## **Spokane Park Board Agenda**

## Design-Build Change Order Form

Change Order Number: <b>3</b>	Change Order Effective Date: <b>5/11/18</b> (date when executed by both parties)
Project: <b>PAVILION DESIGN BUILD PROJECT</b>	Design-Builder's Project No:
	Date of Agreement: <b>APRIL 13, 2017</b>
Owner: <b>CITY OF SPOKANE - PARKS &amp; RECREATION DIVISION</b>	Design-Builder: <b>GARCO CONSTRUCTION, INC.</b>

**PAVILION DESIGN BUILD PROJECT**  
**Change Order #3**  
**Backup Documentation**

PROJECT SAVE THE BUTTERFLIES	BY JWG	SHEET NO.
LOCATION SPOKANE	DATE 03 27 2018	M101
CLIENT EXPO 74	CHECKED CJP	JOB NO.
TITLE BUTTERFLY GENERAL ASSEMBLY	DATE 03 27 2018	-

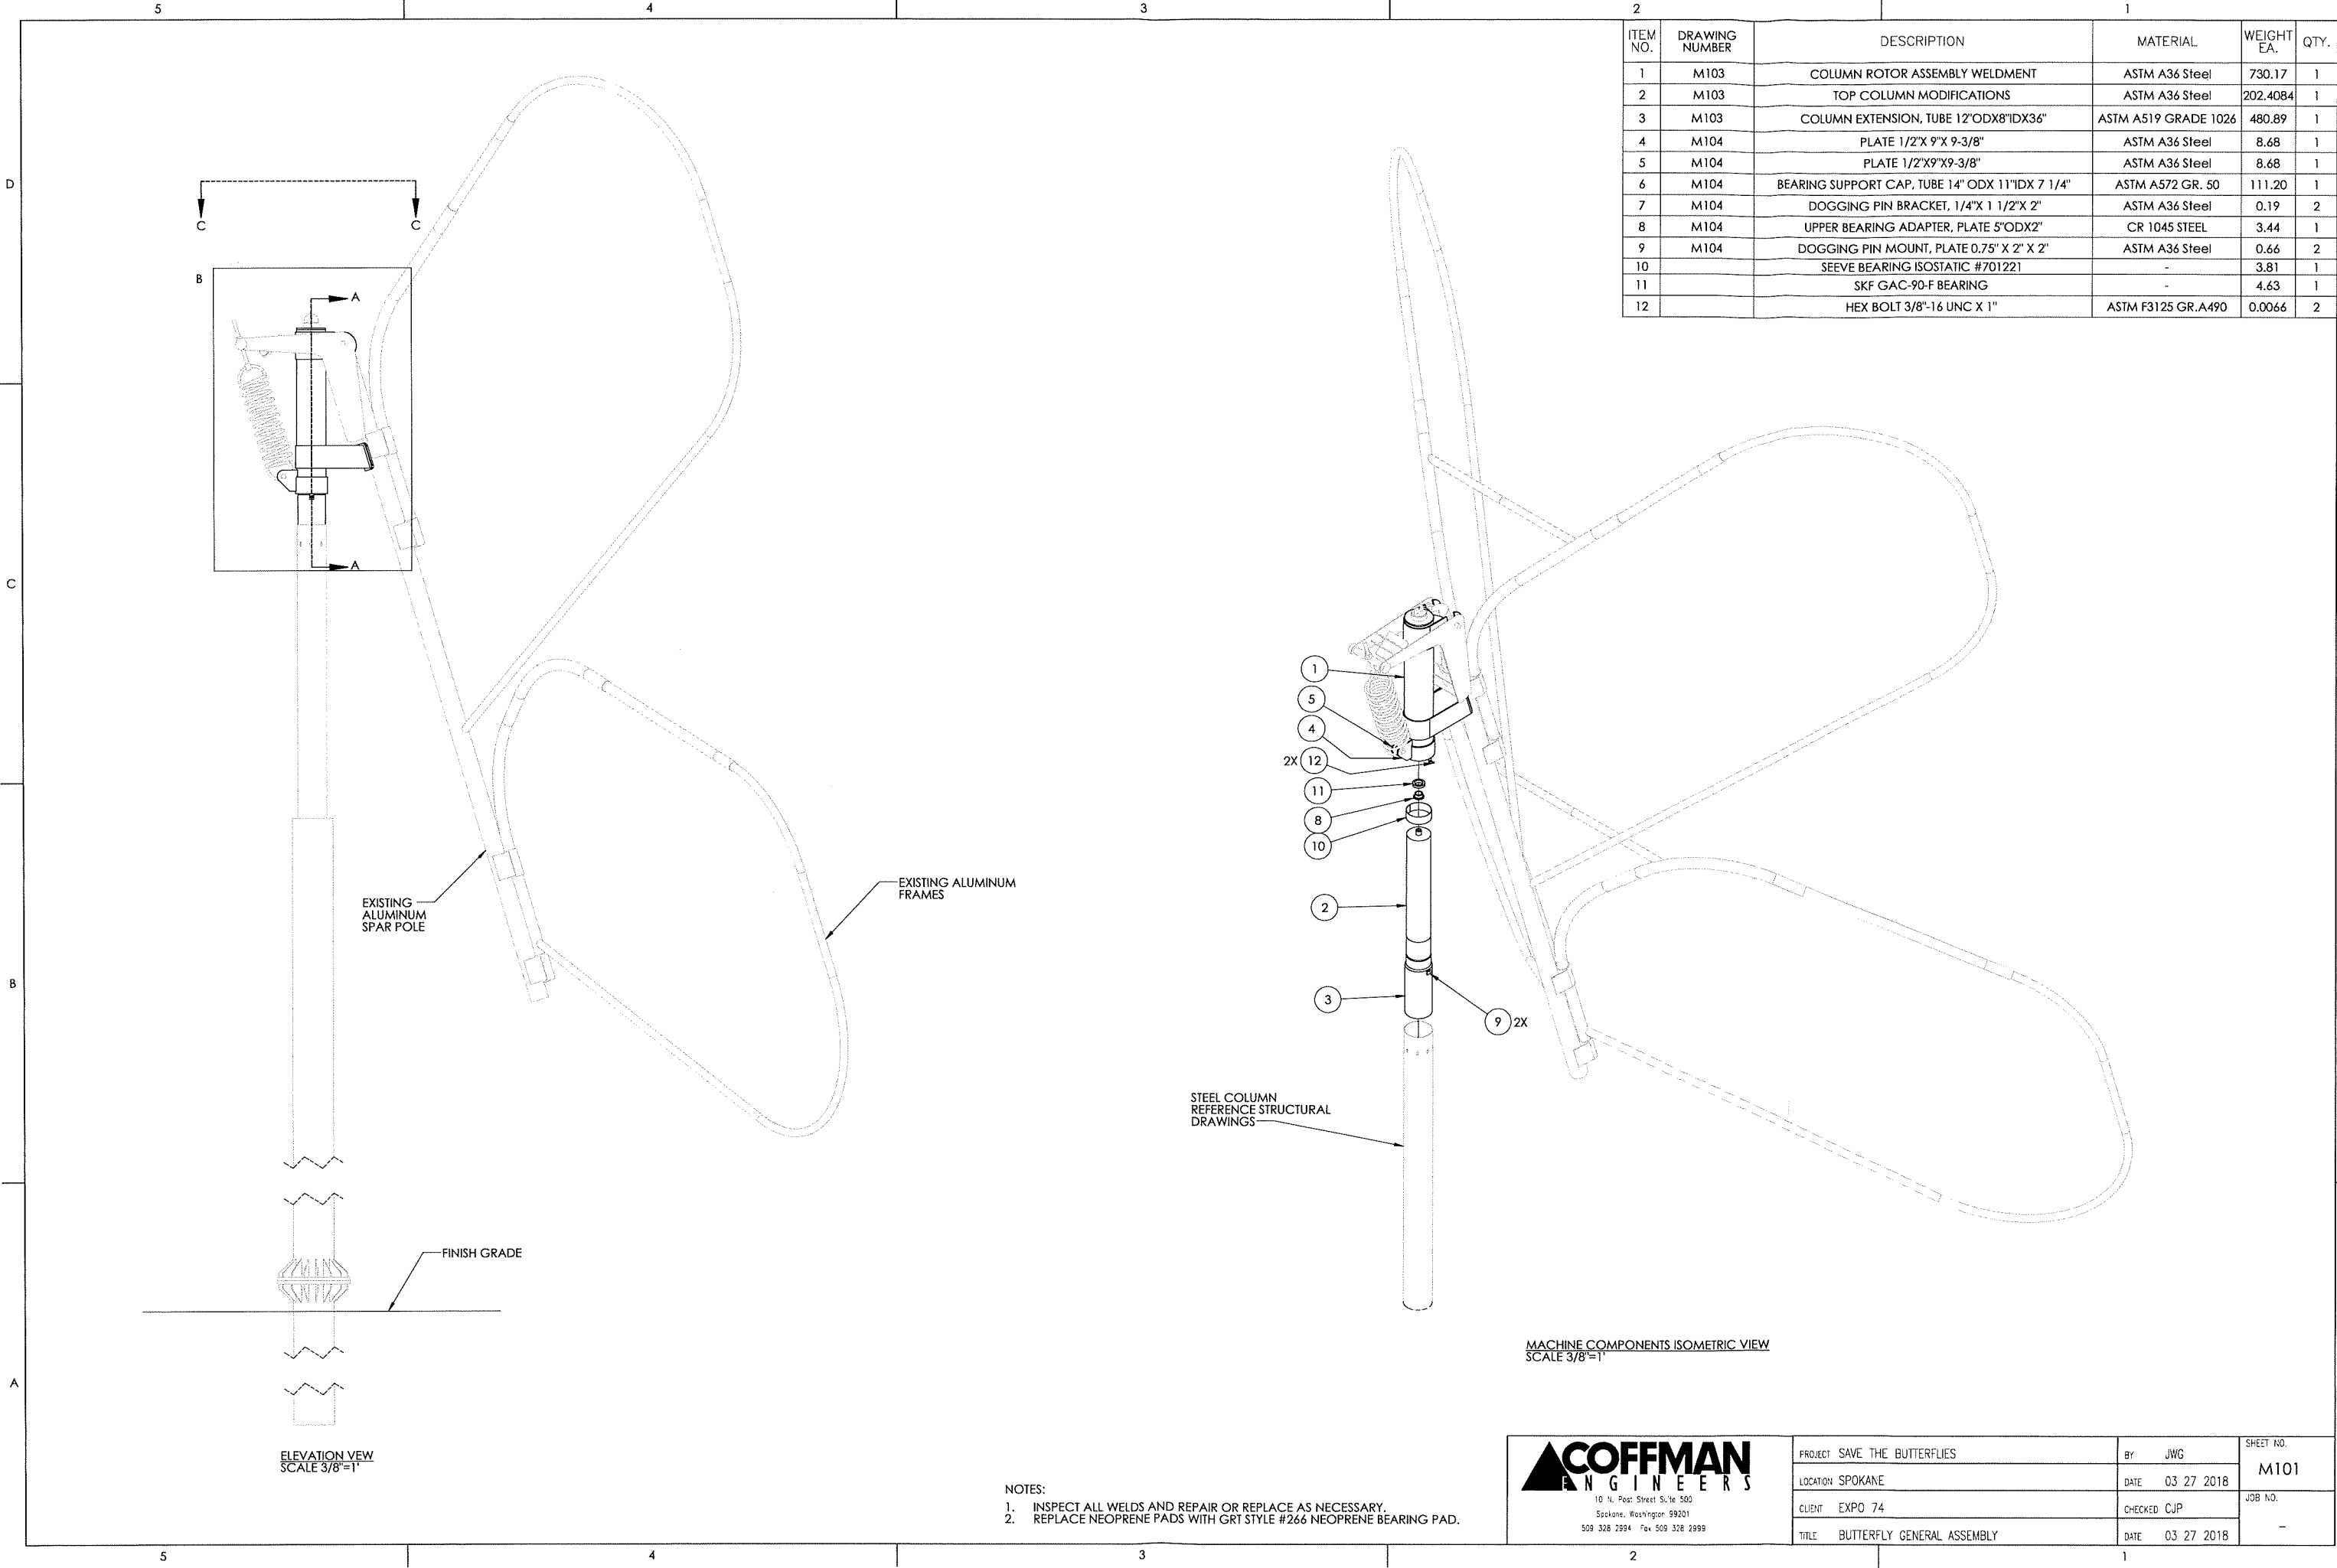
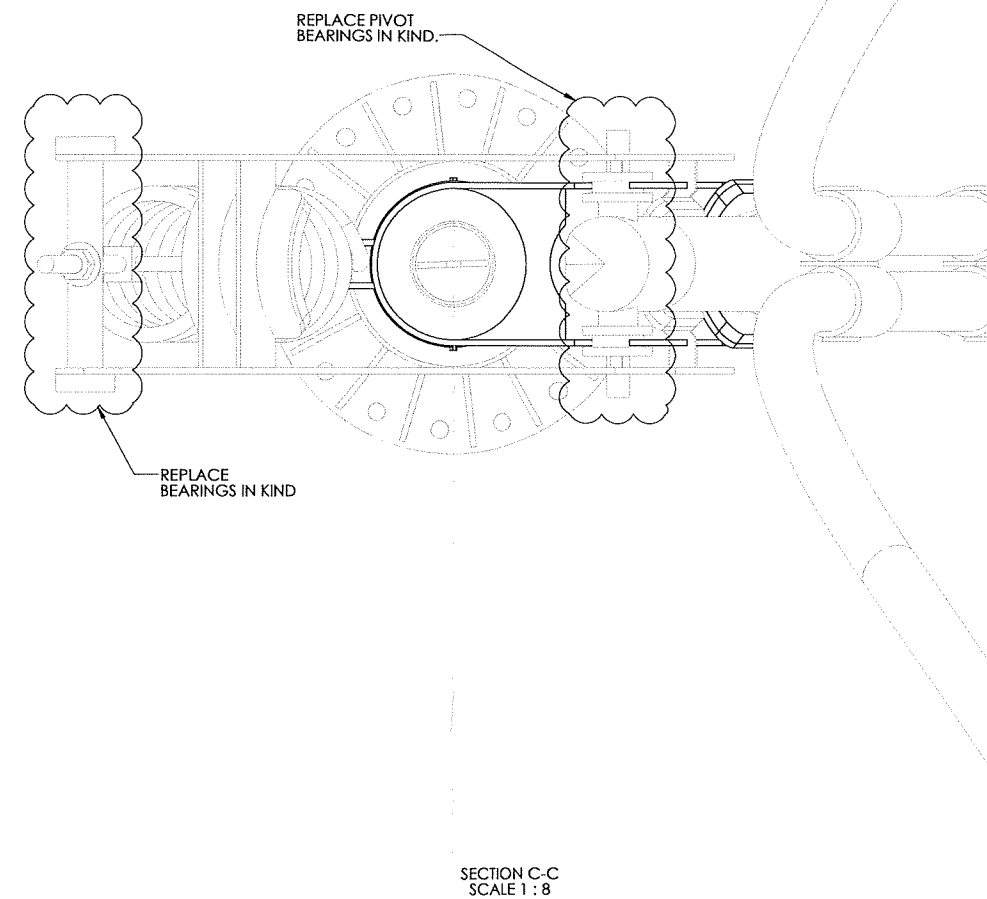
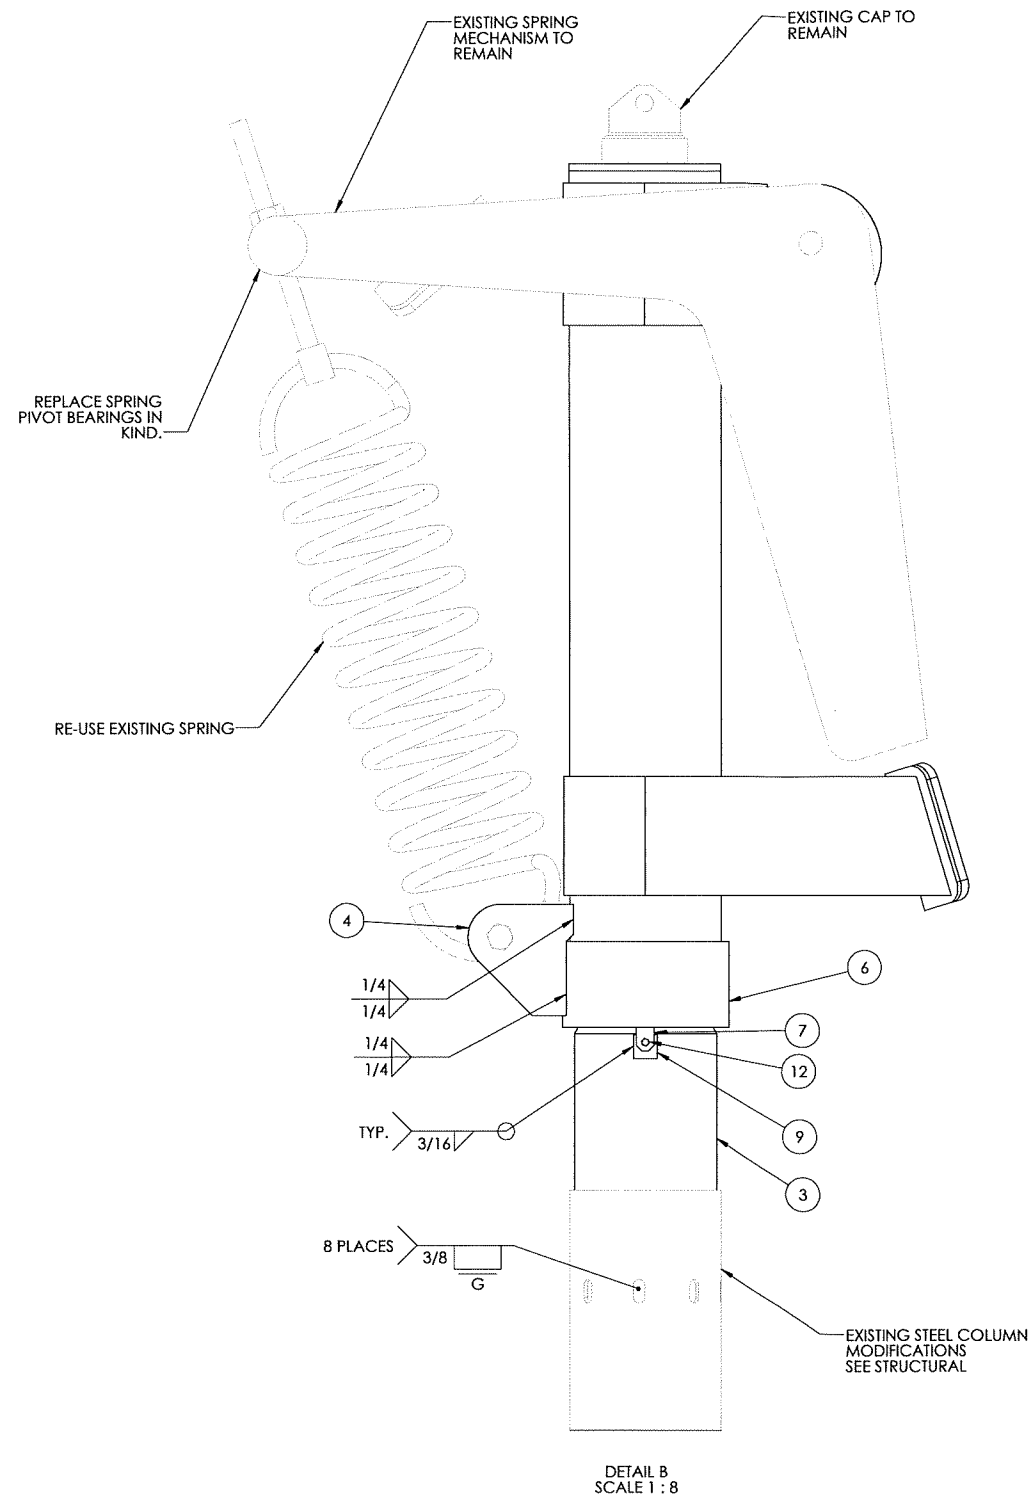
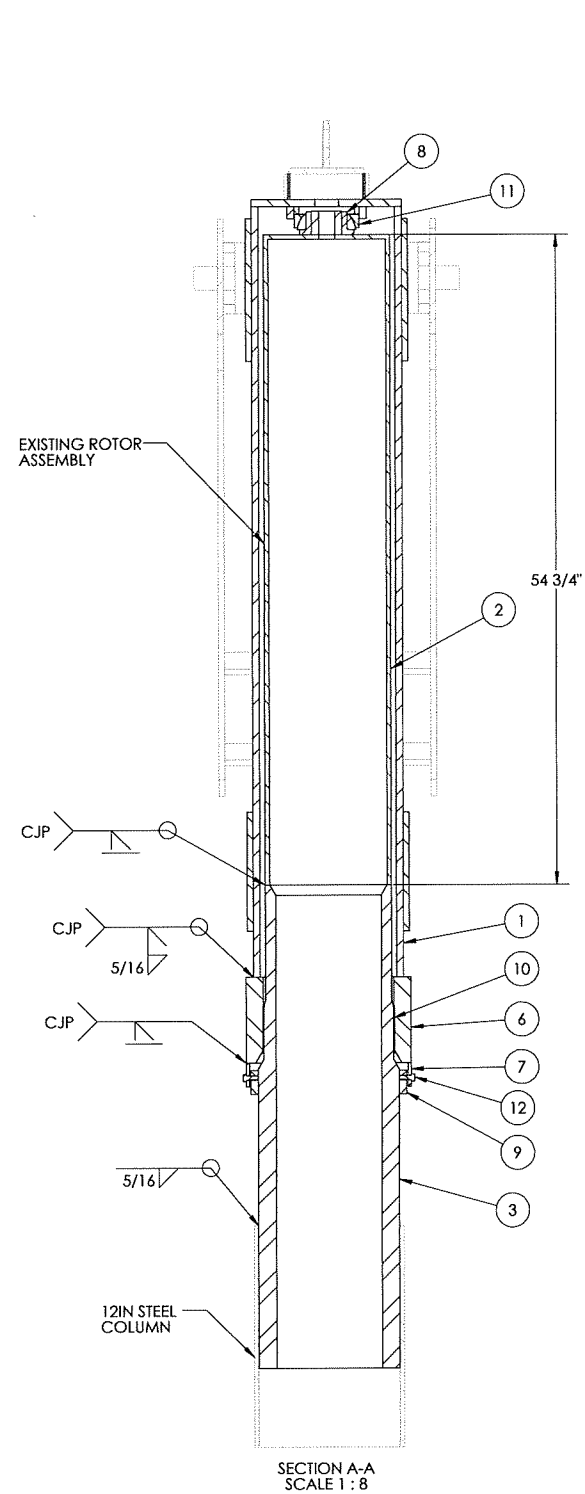
1. Please provide assistance to Coffman Engineers to dismantle the existing Butterfly so they can evaluate what is needed to rebuild it. Pothole the new proposed footing location for soils/rock information for the new foundations. Work with GeoEngineers to verify the footing design. Then work with Coffman and Guildworks to complete the Butterfly design. Provide electrical rough-in for future lighting. Provide the Parks a price to replace the Butterfly by March 25, 2018 in order to get Park Board approval to proceed. This Part 1 work will be done on a T&M basis with a Not to Exceed amount of \$10,000.
2. After NTP, Rebuild and Reinstall the Butterfly as part of the Promenade Finishes for the pricing developed in Part 1.

- Remove Existing Butterfly (Body, Mast and Guidelines) from Current Location
- Demo Existing Concrete Foundations and Dispose of Materials
- Haul and Refurbish Existing Butterfly Body and Wings per Coffman Engineers Design
- Fabricate and Install New Mast
- Excavate and Core Drill Basalt (22" Diameter Hole) for New Anchor Point
- Place New Embedded Anchor Base Plate.
- Re-Install Body and Wings
- Sandblast and Paint Butterfly Body and Mast
- Install new Fabric Wings (Instructional Video Included for Parks)
- Final Cleanup
- Modified Landscaping at Butterfly is yet to be determined

- NOTES:
1. INSPECT ALL WELDS AND REPAIR OR REPLACE AS NECESSARY.
  2. REPLACE NEOPRENE PADS WITH GRT STYLE #266 NEOPRENE BEARING PAD.

PROJECT TITLE:	
HOWARD STREET SOUTH CHANNEL BRIDGE	
SHEET TITLE:	
ELECTRICAL BRIDGE SITE PLAN

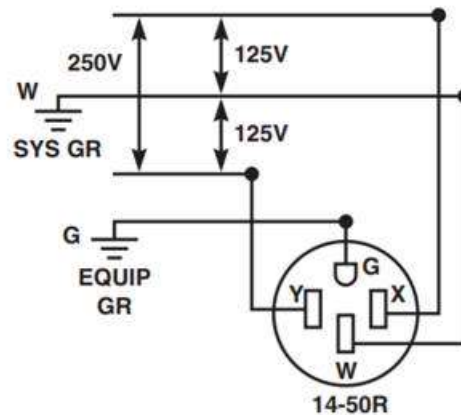
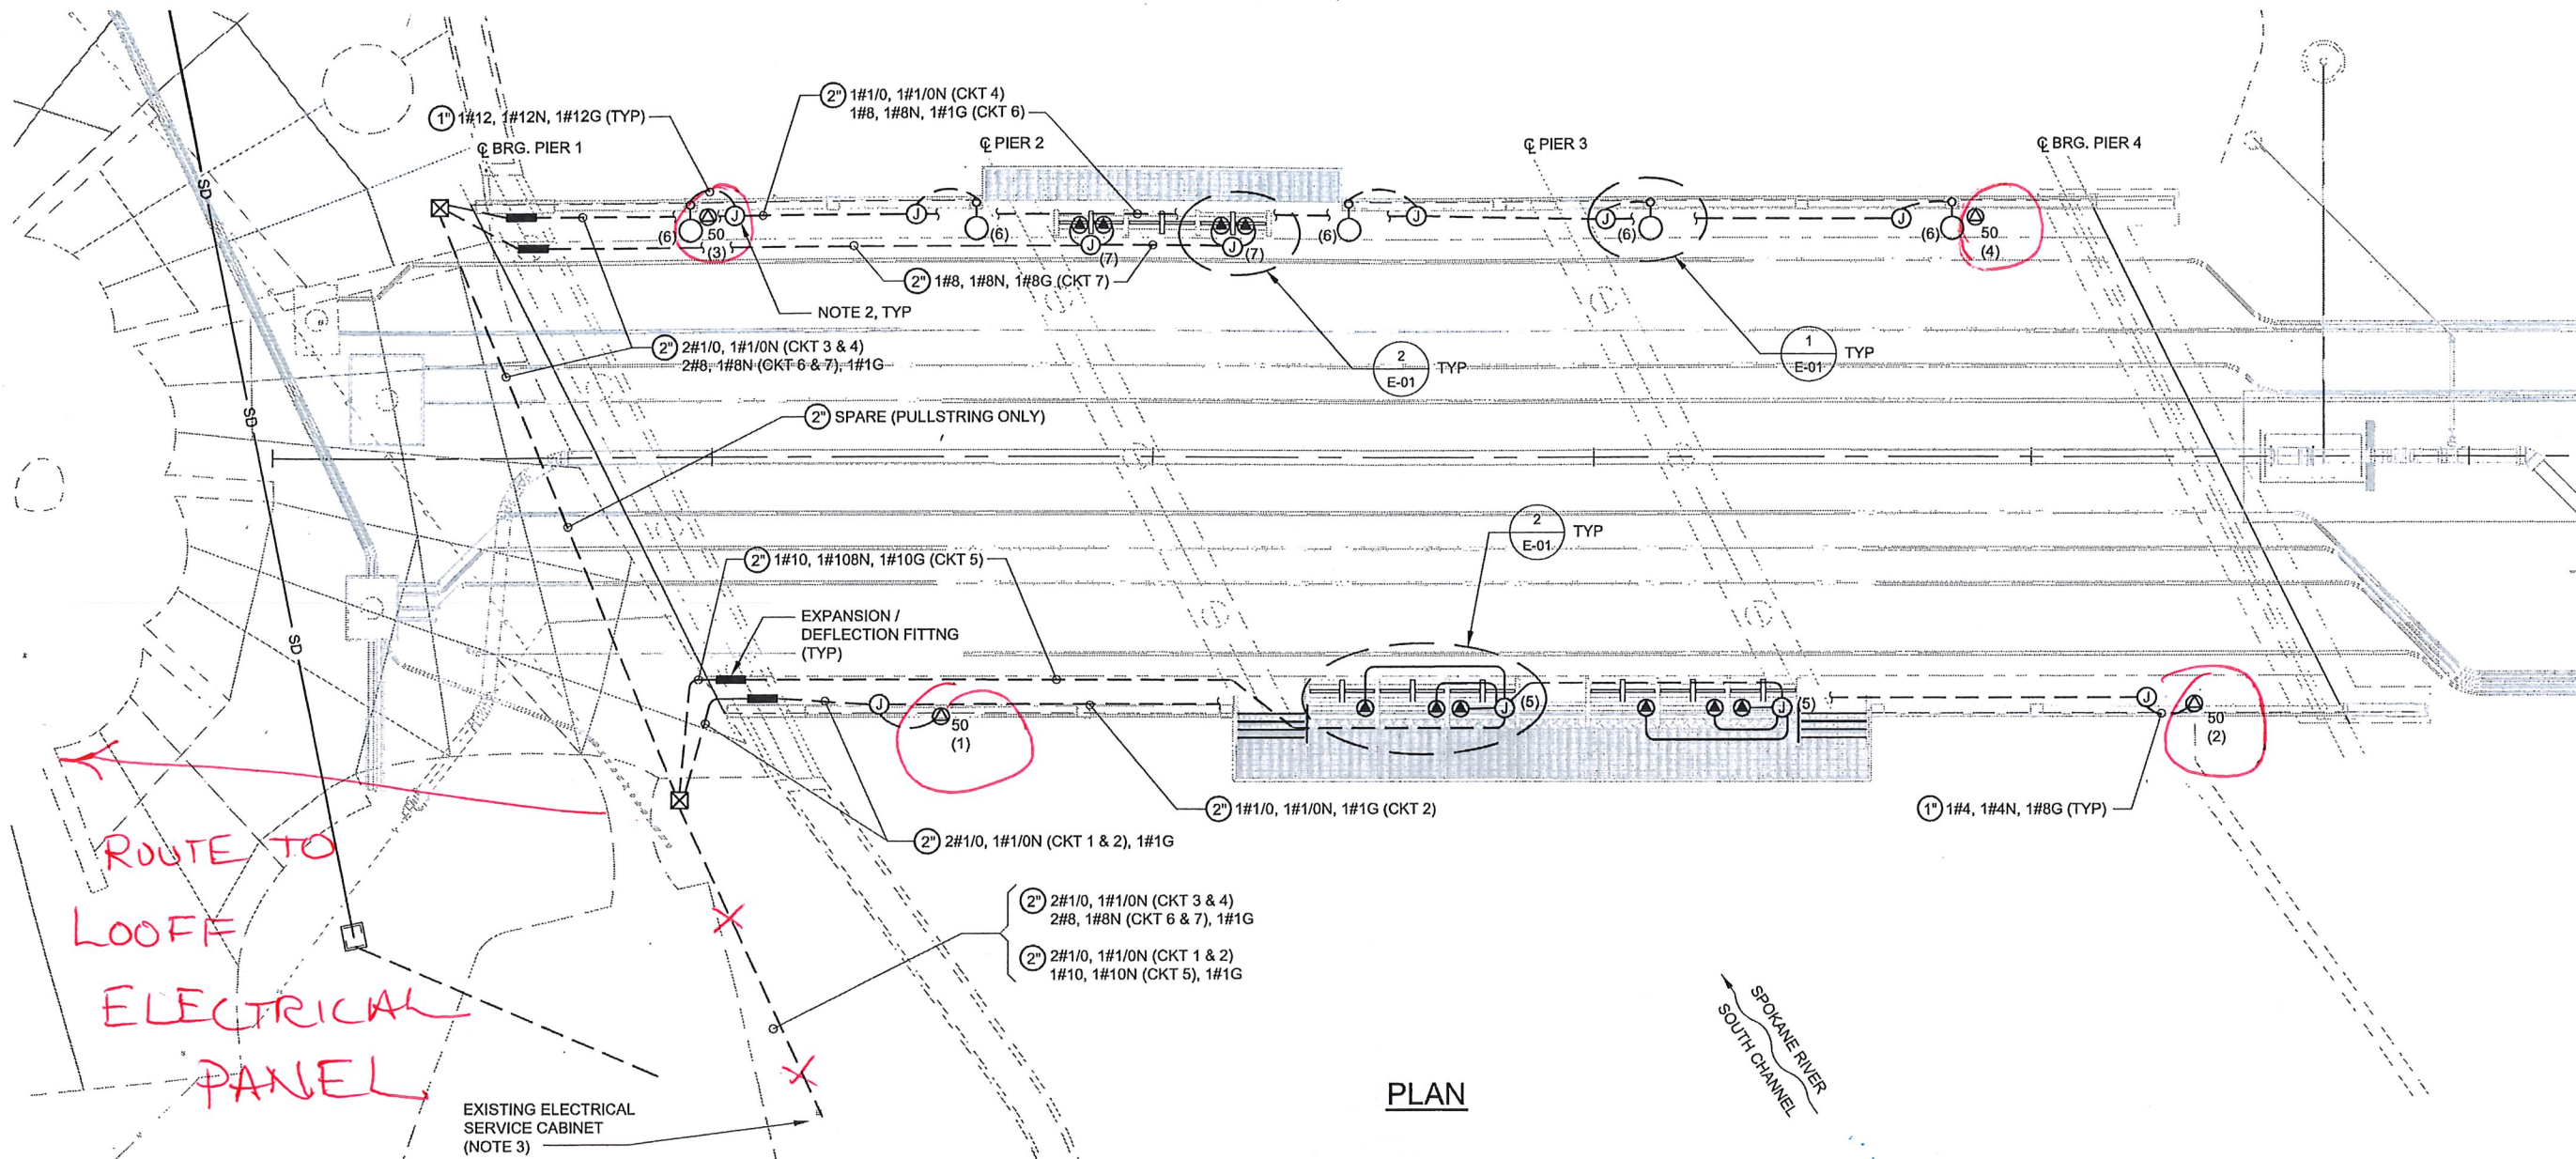
**Description:** Provide pricing to replace the 4 - 50 Amp Receptacles on the Howard Street South Channel Bridge base on the following scope and attached drawing. This work needs to be completed by May 4, 2018.

1. Replace four 1P-50 amp receptacles in Intermatic Type WP1250MDX box with four 2P-50 amp Leviton #279 receptacles. Verify Leviton receptacles will physical fit in Intermatic box and that the box provide NEC 406.9(B)(2) protection.

2. Remove existing wiring service to four 1P-50 amp receptacles unless existing wiring is sufficiently sized (see item #3) and tests acceptably.
3. Reuse existing conduits to provide four home run circuits. Provide 3#4 and 1#8G wires to each Leviton #279 receptacle.

- - Please note that although the rated voltage is 250 volt, we are supplying 208 volt (the same as existing Pig out in the Park locations).
4. Provide and install four 2P-50 amp circuit breakers at Fountain Panel.
  5. Terminate home run circuits from Item #3 to circuit breakers from Item #4.

- SEE E-01 FOR ELECTRICAL LEGEND, LUMINAIRE SCHEDULE, AND DETAILS.
- SPLICE CONDUCTORS IN J-BOX. USE WATERPROOF SPLICES, POLARIS TYPE SSWB, OR APPROVED EQUAL.
- PROVIDE 4-50A/1P CIRCUIT BREAKERS IN THE EXISTING SERVICE CABINET, LABEL "FESTIVAL OUTLET-SW, NW, SE, NE" AS APPROPRIATE. PROVIDE 2-20A/1P CIRCUIT BREAKERS, LABEL "STREET LIGHTS" AND "BENCH LIGHTING". ALL NEW CIRCUIT BREAKERS SHALL MATCH THE SAME TYPE AND AIC RATING AS IN THE EXISTING SERVICE CABINET. PROVIDE A 4-POLE, 30A LIGHTING CONTACTOR, CONTROLLED BY AN INNER DOOR MOUNTED HOA SWITCH, WITH THE AUTO MODE WIRED THROUGH THE CABINET PHOTO CELL. LABEL THE HOA SWITCHES, "STREET LIGHTS" AND "BENCH LIGHTING". CONNECT THE TWO 20 AMP CIRCUITS THROUGH THE NEW LIGHTING CONTACTOR.
